Piper Aircraft, Inc.
 2926 Piper Drive
 Vero Beach, Florida, U.S.A. 32960

SERVICE No. 1154B BULLETIN

SB 1154B supersedes SB 1154A and SB 1154. SB 1154B shortens the repetitive inspection requirement for the engine mount from 100 hours to 50 hours and deleted previous references to "New" Piper.

<u>SUBJECT:</u>	ENGINE MOUNT INSPECTION
<u>MODELS AFFECTED:</u>	<u>SERIAL NUMBERS AFFECTED:</u>
PA-46-500TP Meridian	4697001 through 4697240 and 4697242 through 4697244

Figure 1

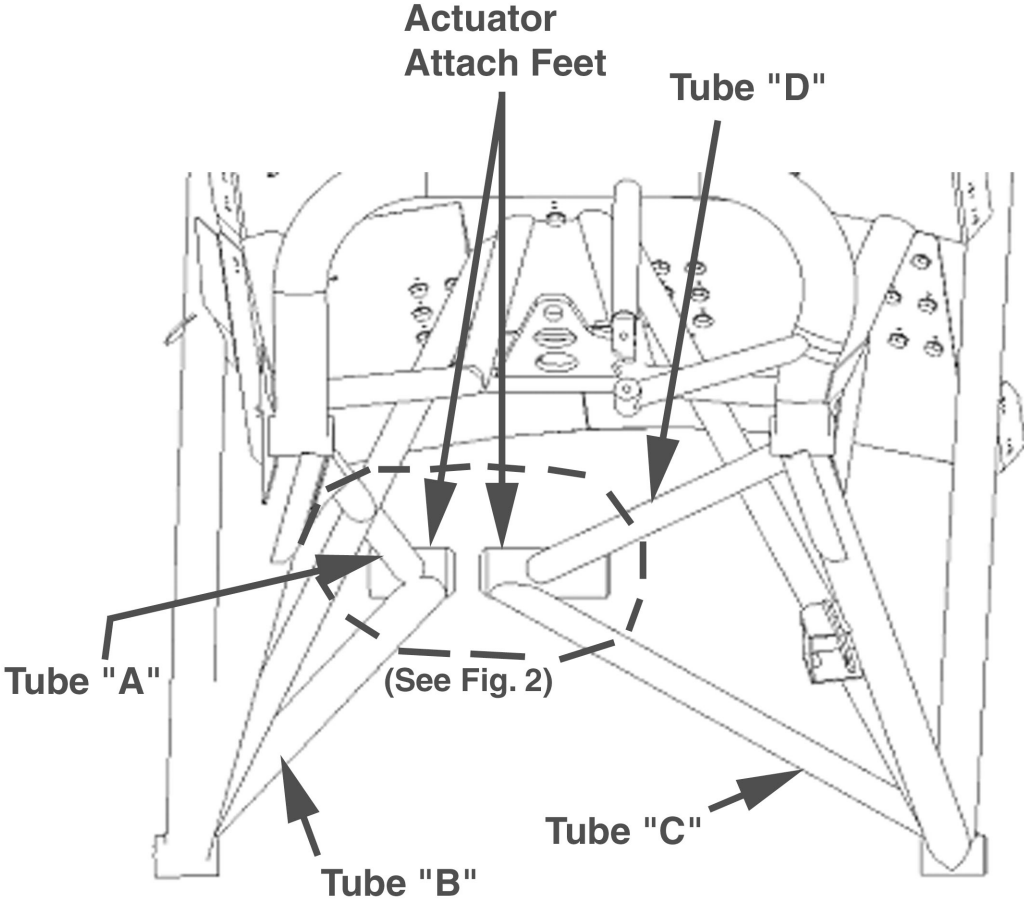
NOTE: This service bulletin is similar to SB1103B except this bulletin requires inspection of the adjacent tubes "A" thru "D" (Fig. 1 and 2) in addition to the attach feet. This bulletin also requires inspection of tubes shown in Fig. 3 and 4 at the left and right side nose gear pivot areas.

PURPOSE: It has been determined that cracks may develop on the engine mount in the area of the nose gear actuator attach feet (see Figure 1 and 2) and in the areas immediately outboard of the nose gear pivot points. The likelihood of this condition occurring increases when the nose landing gear is subjected to repetitive excessive loads, possibly through hard landings, rough field operations, repetitive excessive speed turns and/or improper towing of the aircraft.

1. Remove the nose gear hydraulic actuator and the nose gear assembly from the engine mount per the Aircraft Maintenance Manual, Chapter 32-20-00. Clean the engine mount actuator attach feet area including tube welds as shown in Fig. 1 and 2. Clean the inboard sides of the mount within 2 inches of the nose gear attach points as shown in Fig. 3 and Fig. 4.

3. Visually inspect the engine mount welds and the tubes as shown in Figure 1 thru 4 for cracks.
4. Perform a 'liquid penetrant inspection' of the engine mount in specified areas for cracks per AC 43.13-1B, Change 1, Chapter 5, Section 5.

5. Inspect the entire length of each weld on the attach feet. A mirror will be required to inspect the upper surface of the attach feet and associated tubes. If a crack appears, the engine mount must be replaced before further flight as outlined in Part II (see below).
